**Subject: Snowy 2.0 - Transmission Connection - Construction Independent Environmental Audit #3**

**SNOWY 2.0 TRANSMISSION  
CONNECTION PROJECT**

Independent Environmental Audit  
Construction Audit 3

**Figure 1** Average mulch cover and sample plot post clearing VI score (LENECO, 2025)

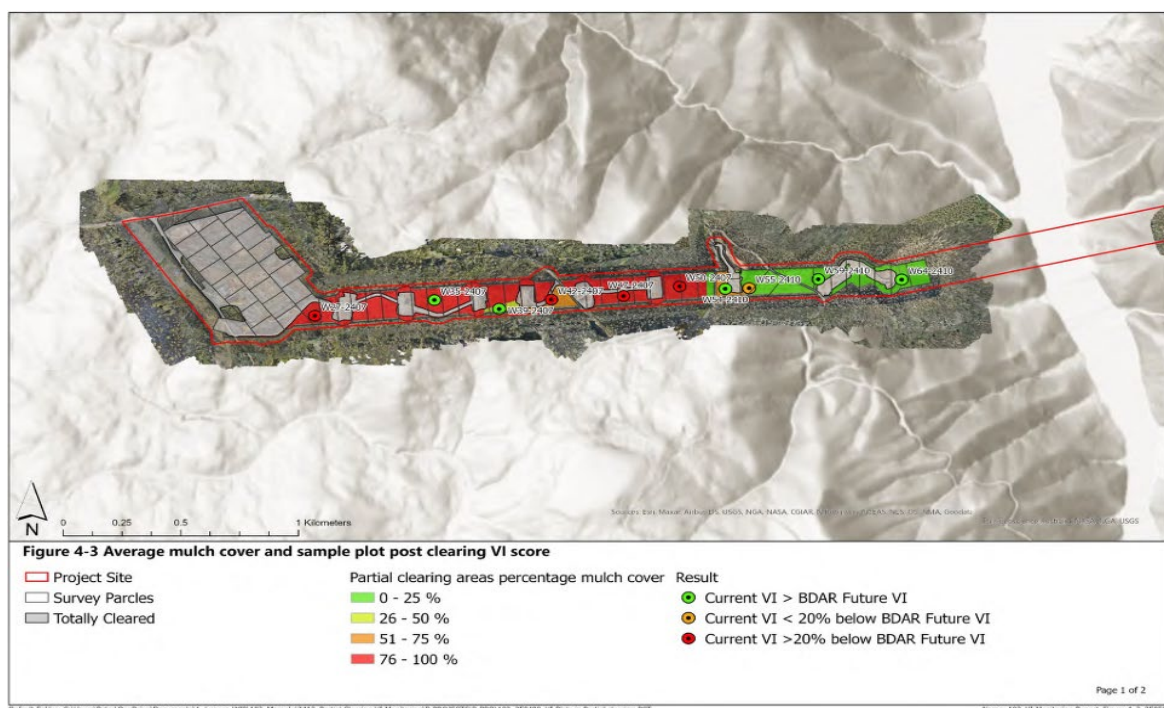
Within the Easement Clearing Zone (ECZ) on the Project West between the Maragle Switch Yard and Track 1 over an area of approximately 1.5km of the easement, significant groundcover disturbance was observed (refer to **Plate 8**, **Plate 9**, **Plate 10**, **Plate 11**, **Plate 12**, **Plate 13**, **Plate 14**, **Plate 15**, **Plate 16**, **Plate 17** and **Plate 18** in **Appendix 5**). Specifically, the retention of managed shrub and groundcover vegetation appeared to be compromised due to the use of extensive application of woodchip mulch, particularly between the western extent of the Project Area, west from Track 1. This excessive generation and application of mulch is considered to be attributed to failure to adhere to the BMP clearing requirements, which required an excavator mulcher to be utilised for clearing of trees with a diameter under 200 mm. After the site inspection, a Post-clearing Vegetation Integrity Monitoring Report (LENECO April 2025) was provided. The report identified that from February to May 2024, clearing in the ECZ was undertaken using an excavator-mounted mulcher, with Transgrid noting that a forestry mulcher was also utilised for a period in March 2024 however after March was no longer used due to challenges with steeper/undulating terrain. As observed during the audit site inspection the use of these clearing methods has resulted in excessive woodchip mulch and increased ground disturbance, especially in the taller forest areas in Project Area West. The LENECO Report also identified this and mapped an area of approximately 1.5km between Maragle Switch Yard and Track 1 where mulch cover was confirmed to range from 76% to 100% (refer to **Figure 1**). The use of the forestry mulcher on the Project West site did not comply with the BMP's requirement to use a excavator mulcher. The forestry mulcher is not considered a similar machine to an excavator mulcher due to differences in design, mobility, and application. Forestry mulchers are self-propelled, purpose-built machines designed primarily for clearing on-ground vegetation, shrubs, and small trees over large areas, whereas excavator mulchers are attachments fitted to excavators, offering greater flexibility for selective clearing, especially in partial clearing zones.

This non-compliance has likely led to increased disturbance and impacts to shrubs and ground cover vegetation and resulted in excessive woodchip cover that has smothered shrub and groundcover vegetation that was required to be retained. Furthermore, the application of mulch at such depth has likely elevated ground temperatures, potentially degrading the soil seedbank. It is important to note that spreading mulch is not considered a form of rehabilitation and, in this case, may have had the opposite effect by impeding vegetation recovery. The extent of the impacts observed from this have the potential to have resulted in environmental harm (as defined under the Infrastructure Approval).
